Summary/Reason Statement for DRH16-00014

Planning Division Staff Report

File Number	DRH16-00014
Applicant	FH Broncos, LLC – Eran Fields
Property Address	1808 West Boise Avenue
Public Hearing Date	March 9, 2016
Heard by	Design Review Committee
Design Review Planner	Andrea N. Tuning
Design Review Supervisor	Sarah M. Schafer

1 SITE PLAN
SCALE: 1" = 20'-0"

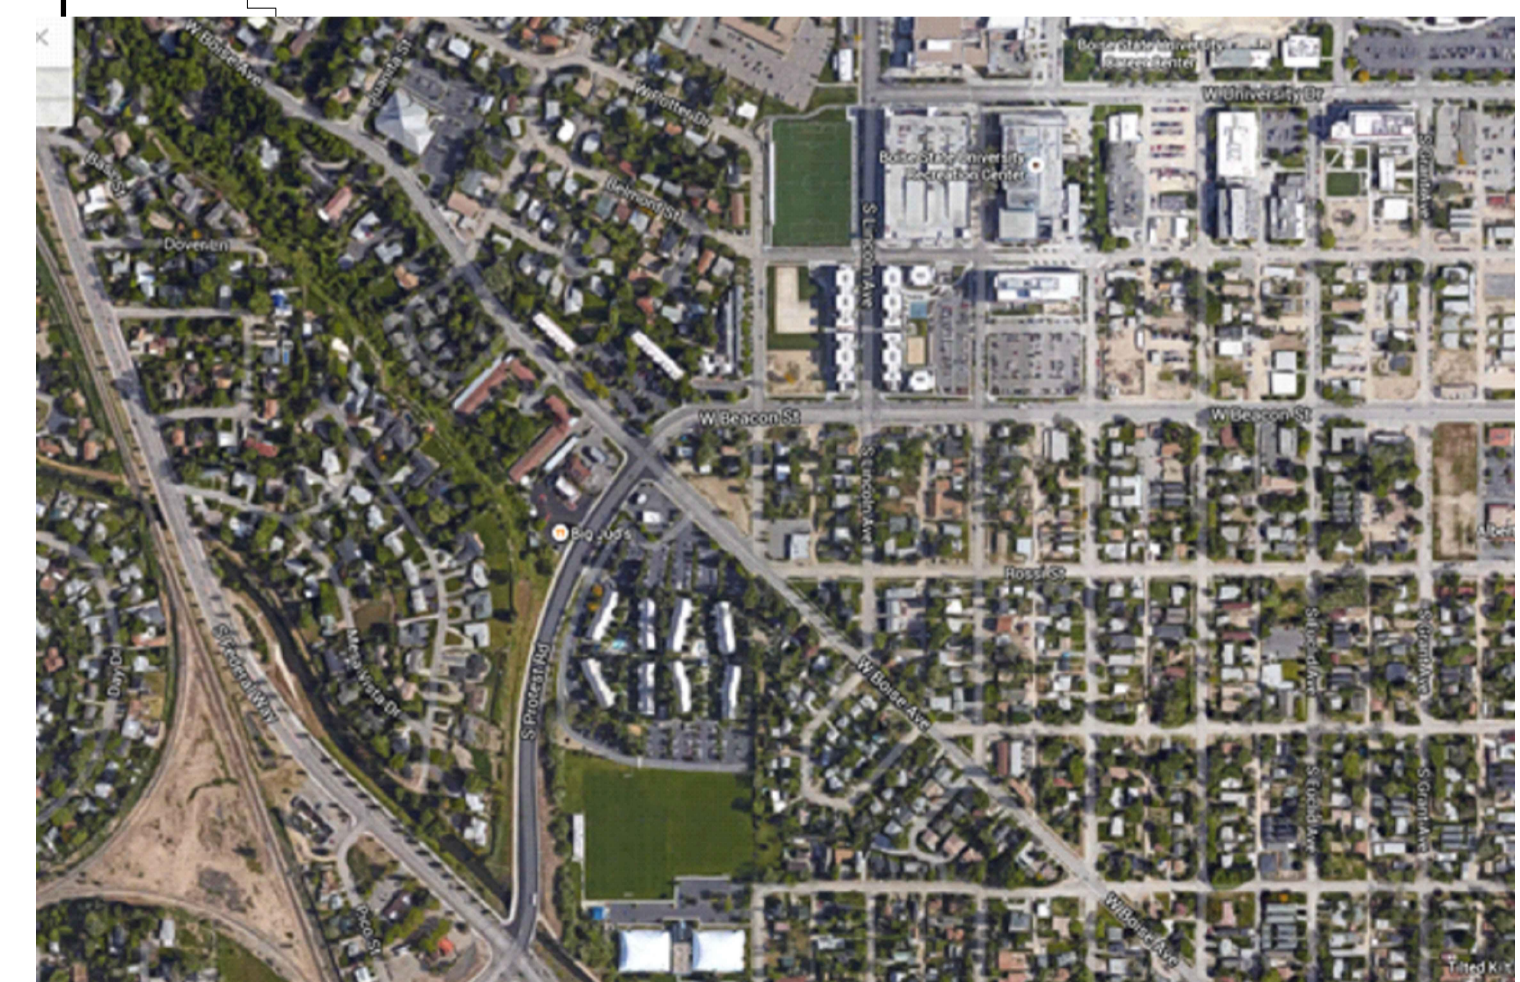
- c. Provide a 3-foot modulation within the wall plane at each location where the building encroaches into the street side setback on Oakland Avenue.
 - d. Eliminate the existing driveway on Boise Avenue and replace it with standard vertical curb and gutter to match the adjacent improvements.

A5.0
 EXTERIOR ELEVATIONS

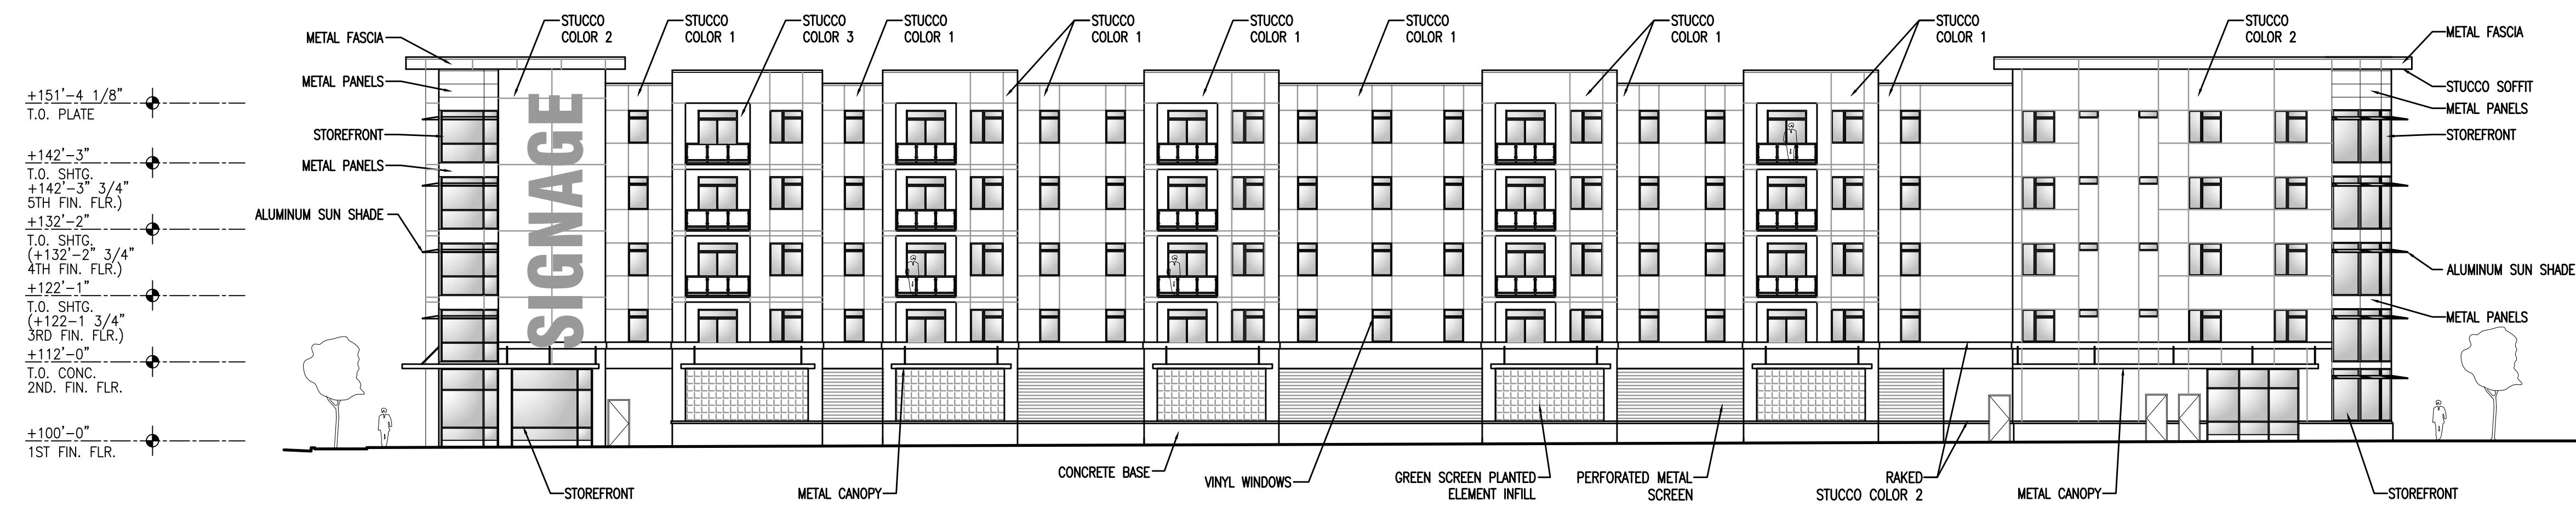
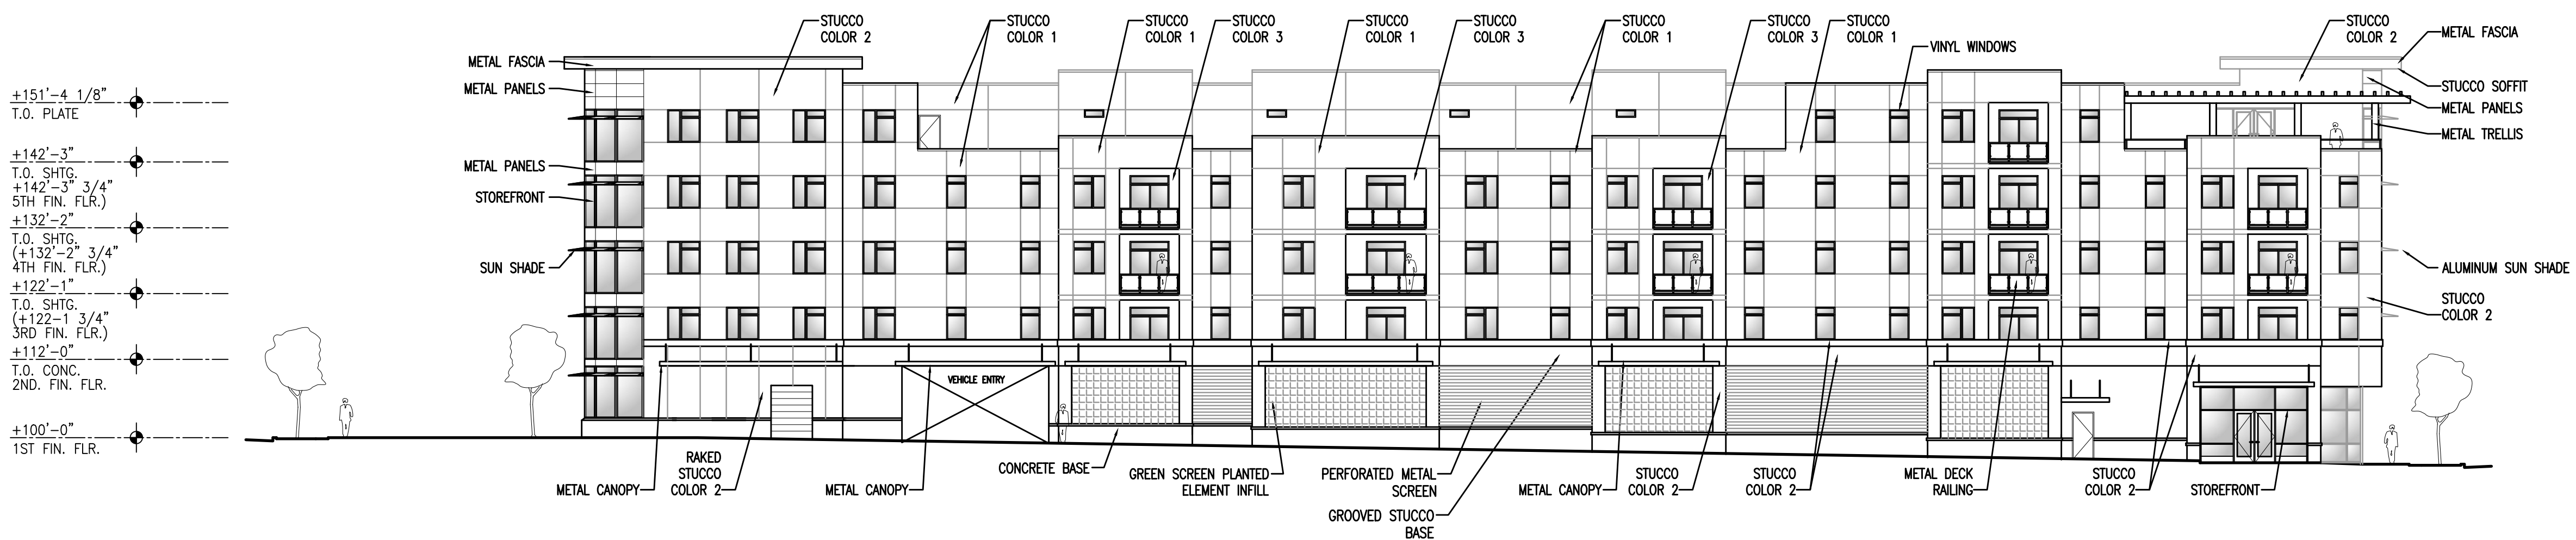
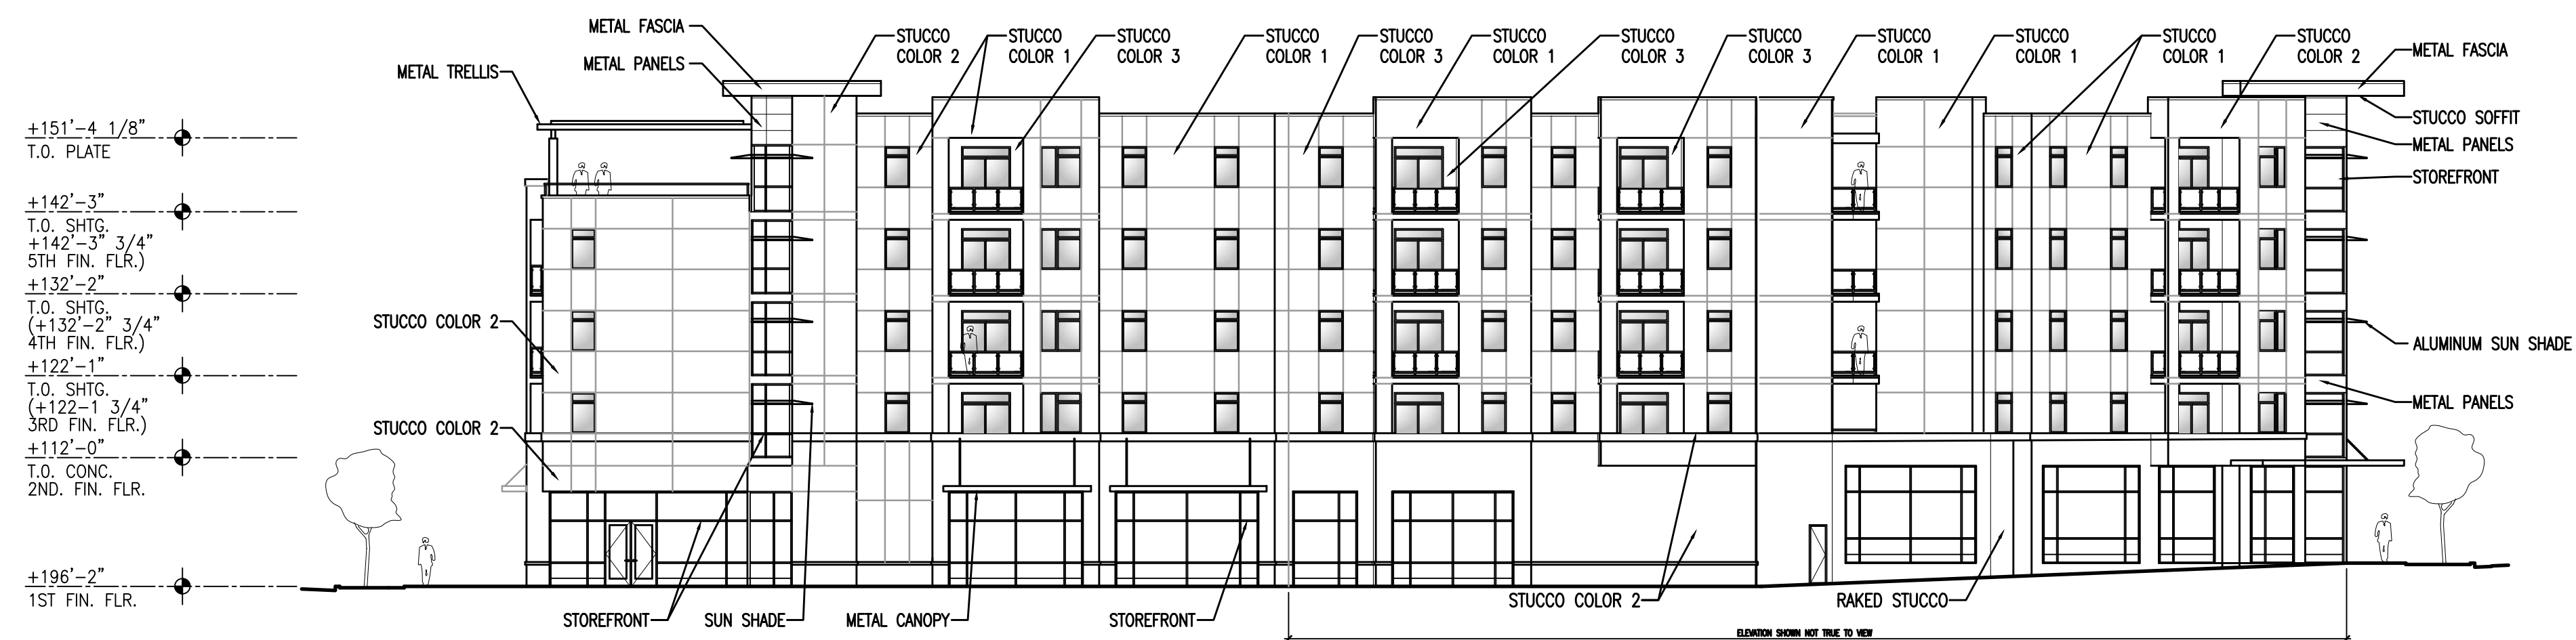
- e. Eliminate the existing driveways on Boise Avenue and replace them with standard vertical curb and gutter to match the adjacent improvements.
 - f. Integrate an additional building material into the materials palette in order to limit the amount of stucco present on the street facing facades to 75-percent.
